City of St. Helens

Planning Commission

July 11, 2017

**CITY OF ST. HELENS PLANNING DEPARTMENT
STAFF REPORT
Conditional Use Permit CUP.3.17, Variance V.2.17, and Variance V.3.17**

1 SITE PLAN
A100 1" = 10'-0"

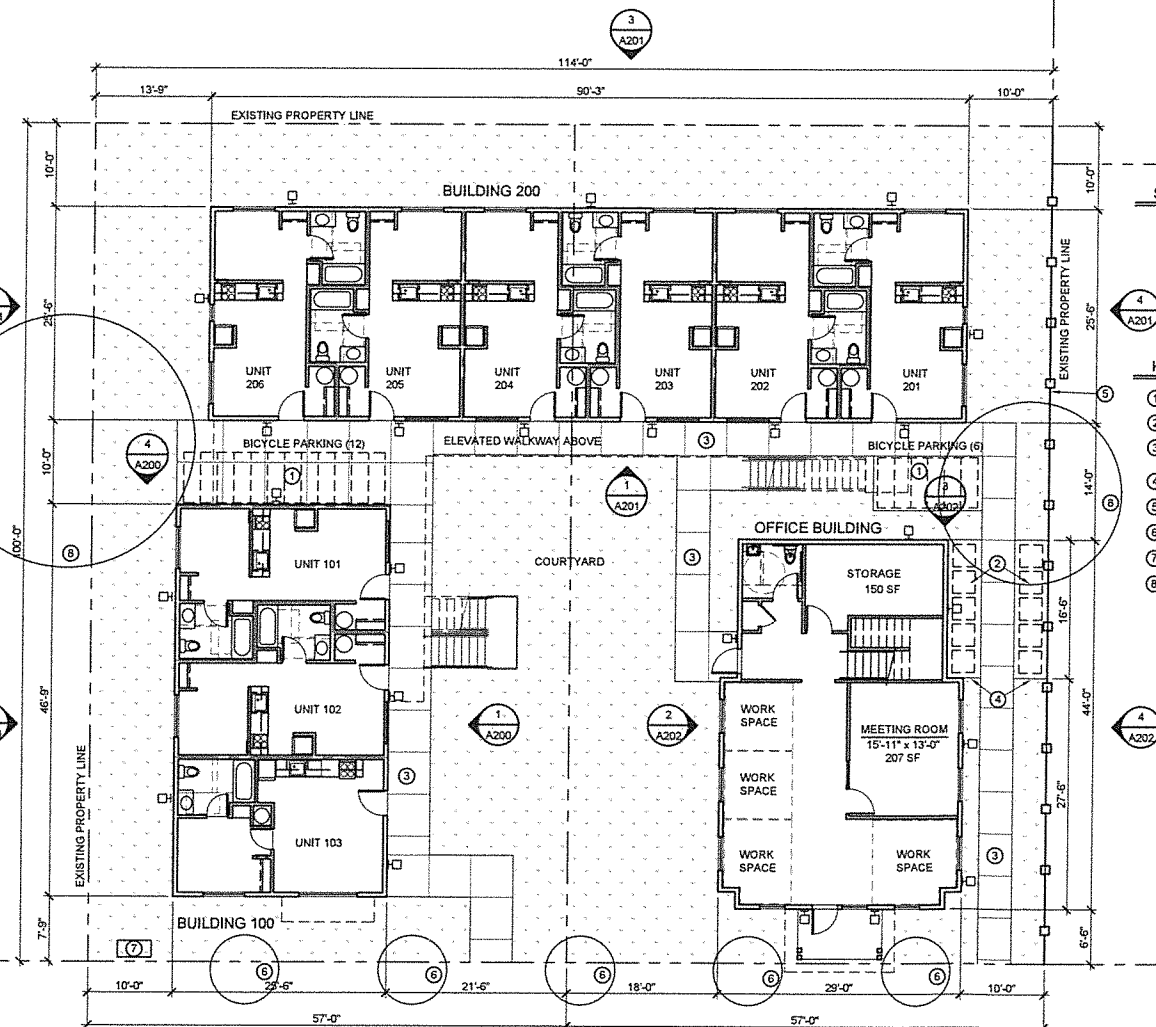
Related to street trees is street classification. 18th Street south of St. Helens Street is classified as a collector. There is an old design curb-tight sidewalk along N. 18th Street along the subject property. If this remains as-is, the street trees would need to be planted behind the sidewalk. However, if the Commission requires the frontage improvements to be re-done to current standards, there would be a landscape strip between the sidewalk and curb, where the trees would go. The Commission needs to determine what frontage improvements are appropriate along N. 18th Street: keep the existing or require reconstruction to current standards.

For multifamily use, each dwelling unit shall be connected by walkway to vehicular parking area, and any common open space and recreation area. The plan provides internal walkways. They connect to the N. 18th Street sidewalk, which connects to the shared parking area, but not directly to the shared parking area. Does the commission think there should be a direct path? There is an existing disabled vehicular parking space, of which the wheelchair access aisle could work as a path free from obstruction (around the NW side of the proposed building). In this case, adjacent improvement need to be included on a revised site plan for proper integration planning.

- ii. Changes to landscape plans to comply the other plans revisions or otherwise comply with the Development Code. For example, applicant shall demonstrate street tree location compliance with SHMC 17.72.035. Things to demonstrate compliance, such as utility poles shall be included on the plans. Street trees along N. 18th Street shall be "Small" as per Chapter 17.72 SHMC.

BUILDING
ELEVATIONS

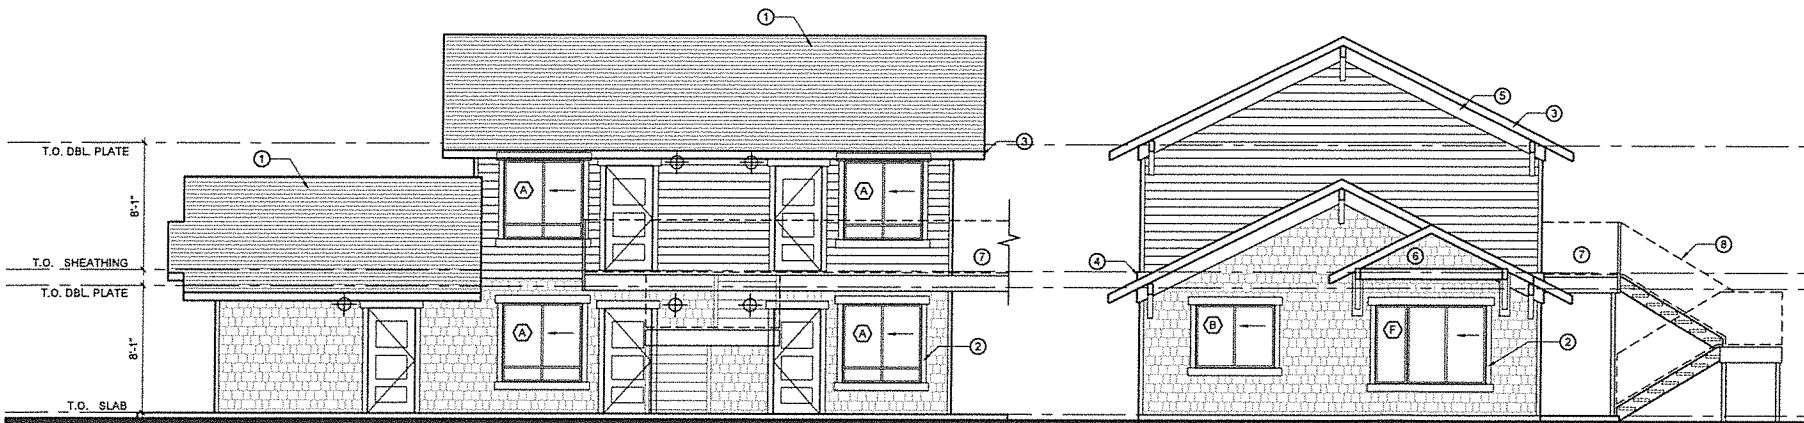
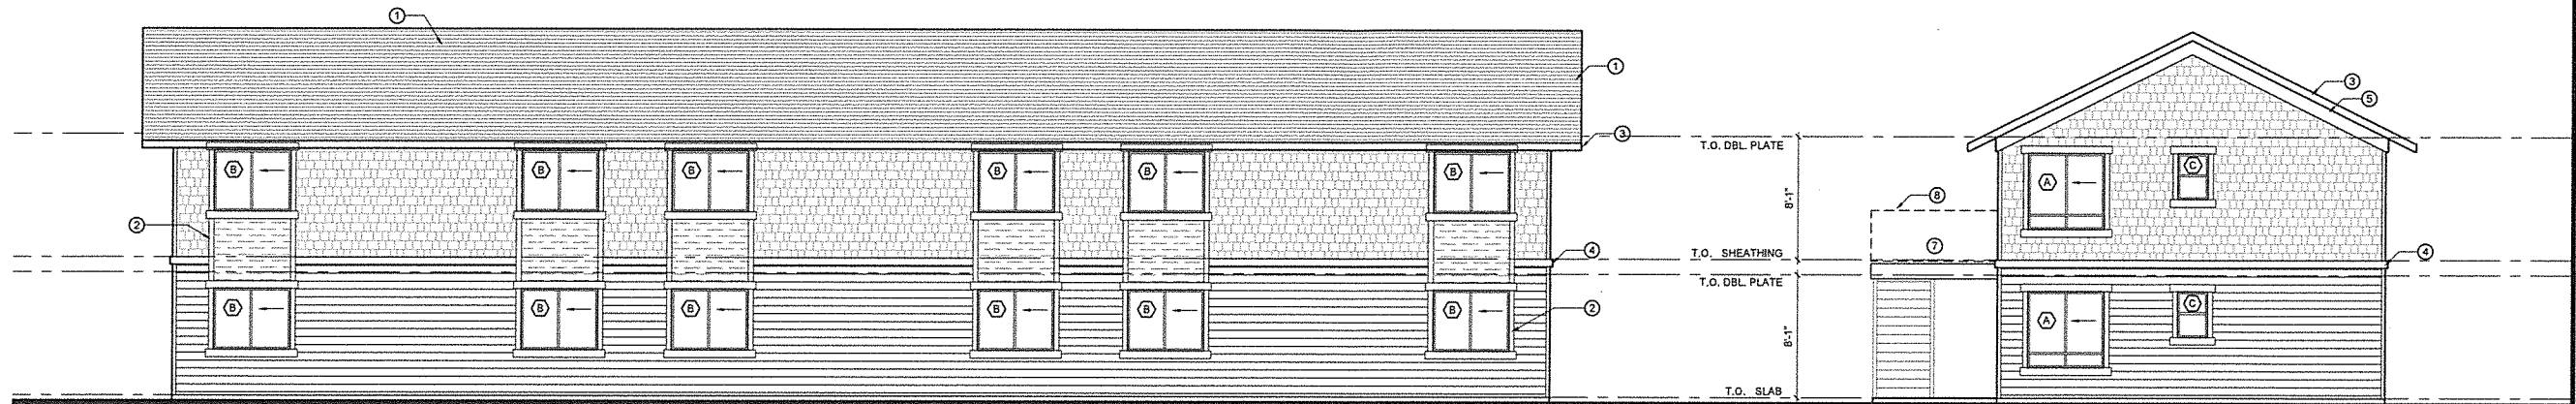
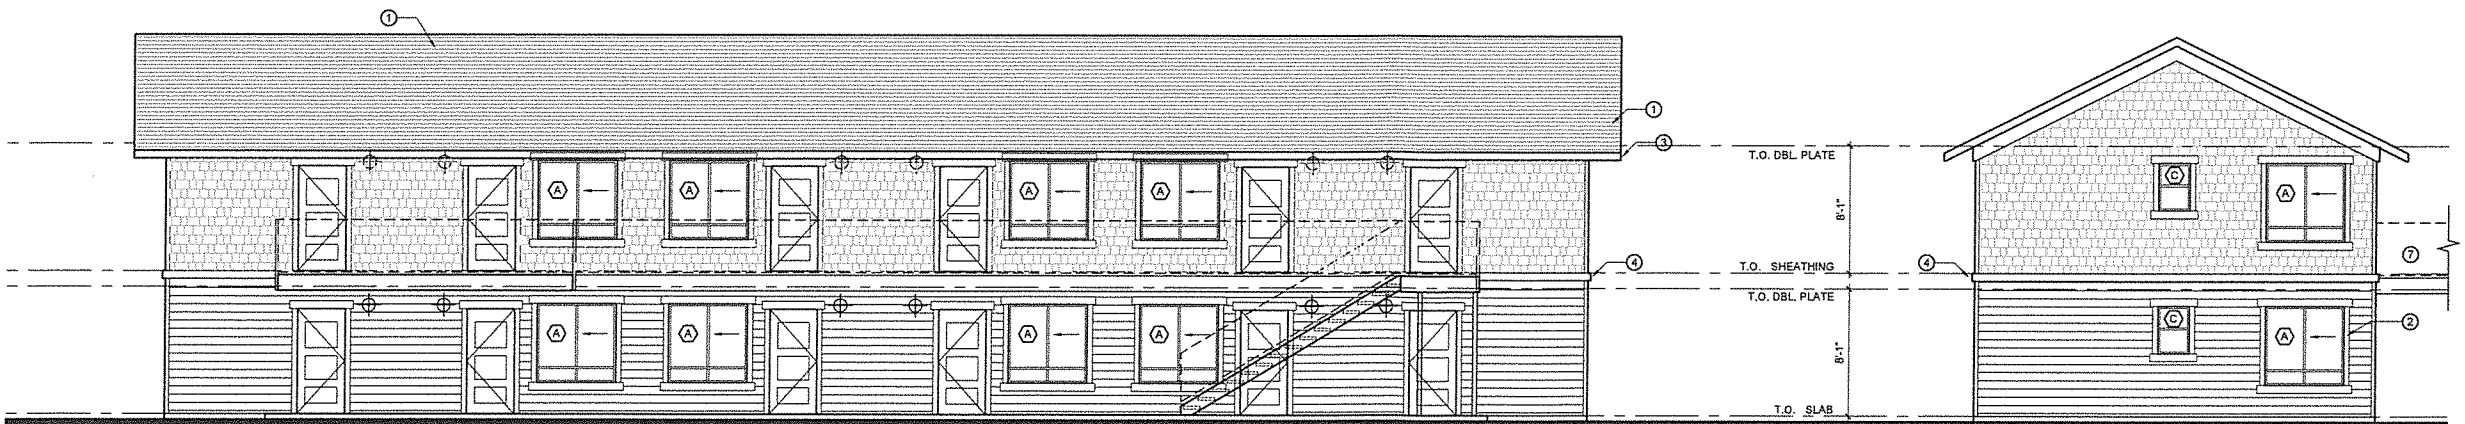
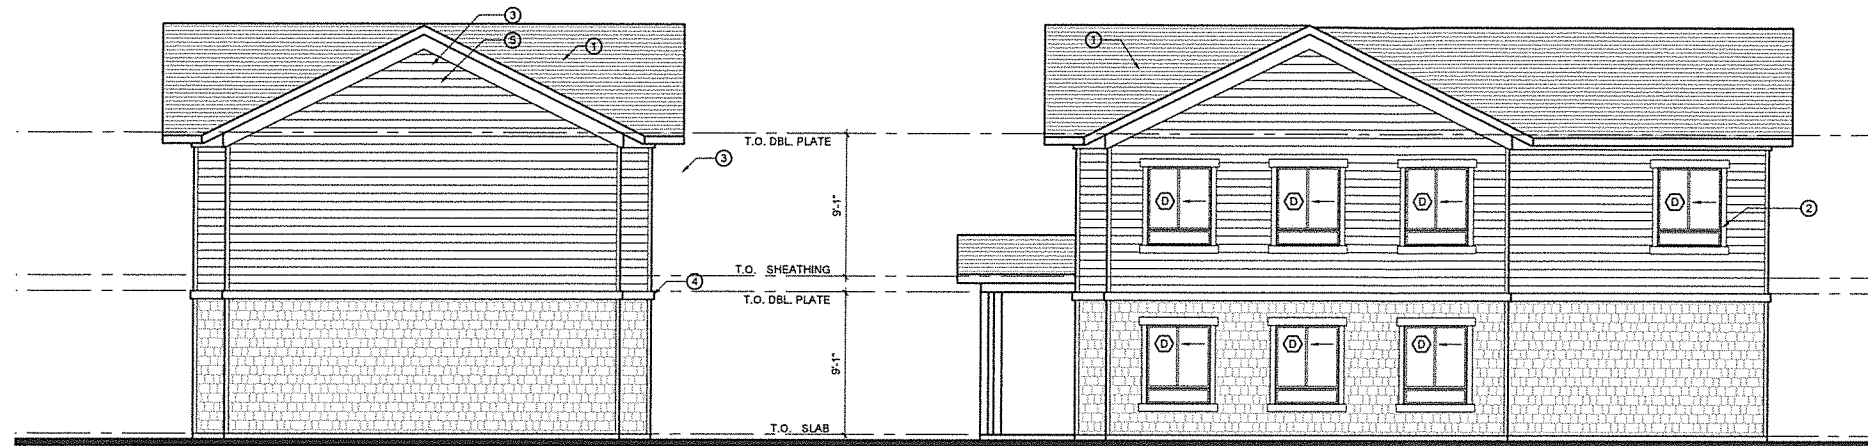
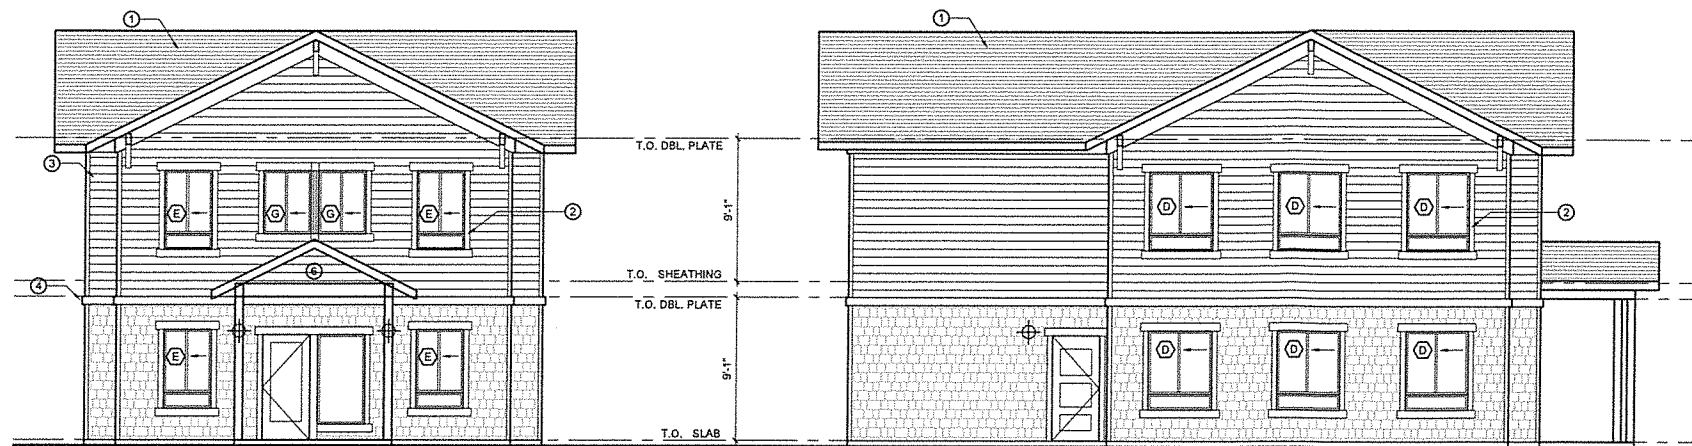
Finding(s): This criterion specifically says that the recesses, extensions or offsets apply to the vertical face of buildings. The applicant feels the proposal meets the intent of the code as a grouping of building despite the code technically applying to each individual multidwelling building. If the Commission concurs, it should make specific findings so this cannot be easily exploited by other multifamily dwelling proposals. This is a classic question for the Commission: will this set a precedence? Other options include but not necessarily limited to requiring a Variance or application denial.

- viii. <<how does the Commission want to handle the exterior elevation requirement? Make a finding to allow as is, impose a condition for revised building plans here, require a Variance, or deny the application, or...>>

Overall Site Plan
SCALE 1" = 20'-0"

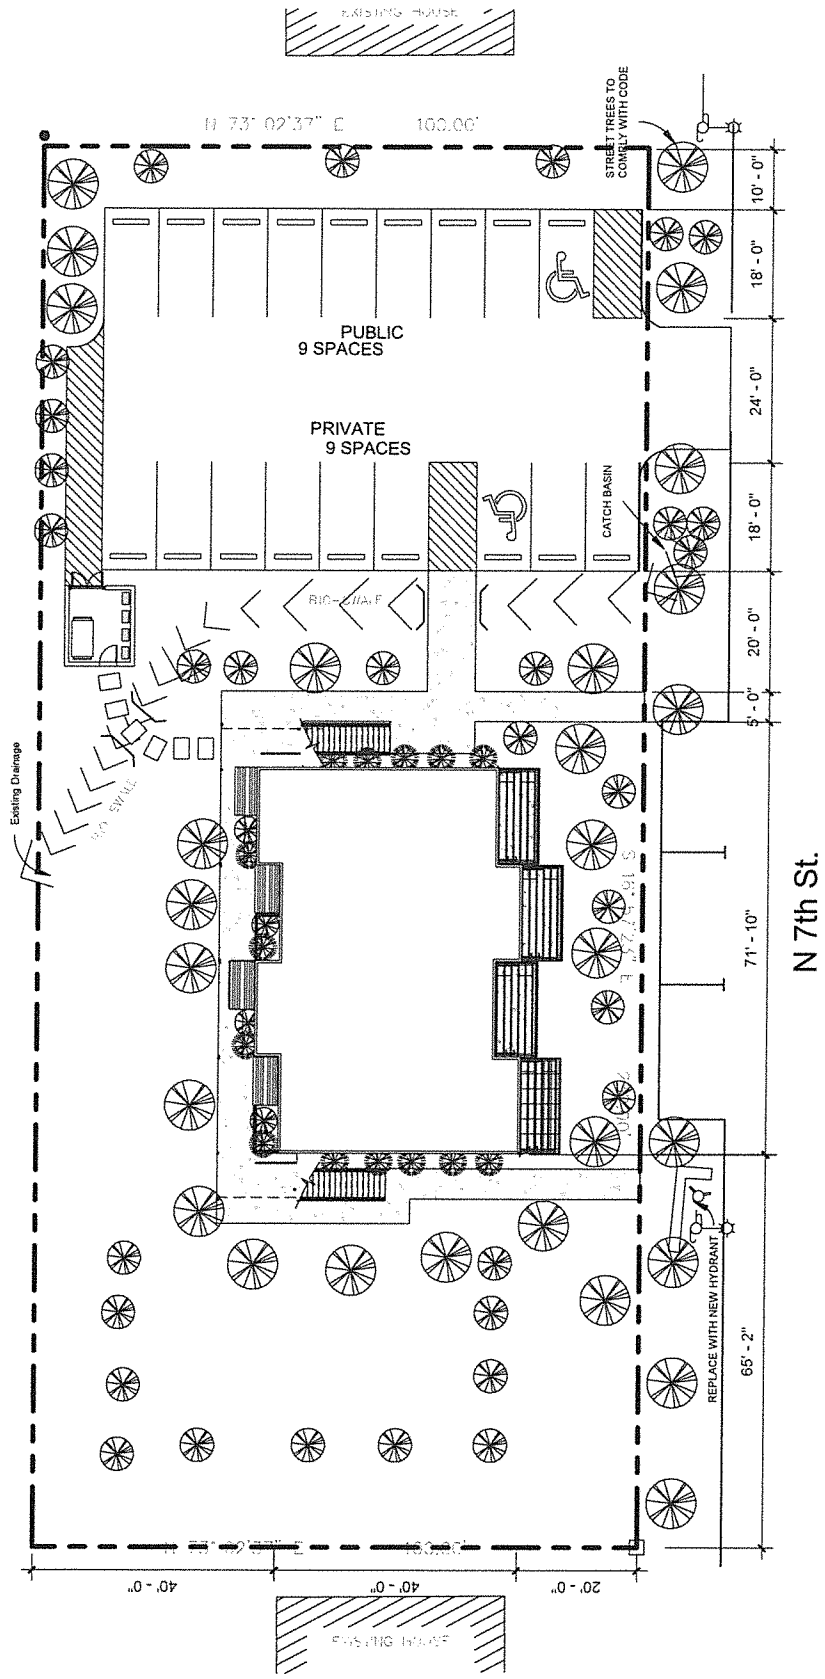
Minimum front yard (setback) required is 20 feet; plans show 20' to the building but also show some type of projections (assumed patio/balcony) that projects 7 feet into the front yard. This is a violation of code. Per SHMC 17.64.050(3):

Bicycle parking is required with 1 lockable space per dwelling unit. Needs to be addressed on revised plans. The building elevation shows bike racks; jut not explicitly labeled on plans.

Finding(s): Plans submitted do not appear to meet at least two of these standards. If the patio extensions were 8' instead of 7' and the offset between "conex units" was 8' instead of 4' it would. Revised plans shall comply. Or based on findings from earlier hearings of the night, does the Commission want to find that this meets the intent of this provision?—this is potential problematic; these standards are clear and objective. When start to stray from them, the clarity and objectivity wanes.

Final plans need to show that that separation from driveways, parking lots and walkways per the above is met.
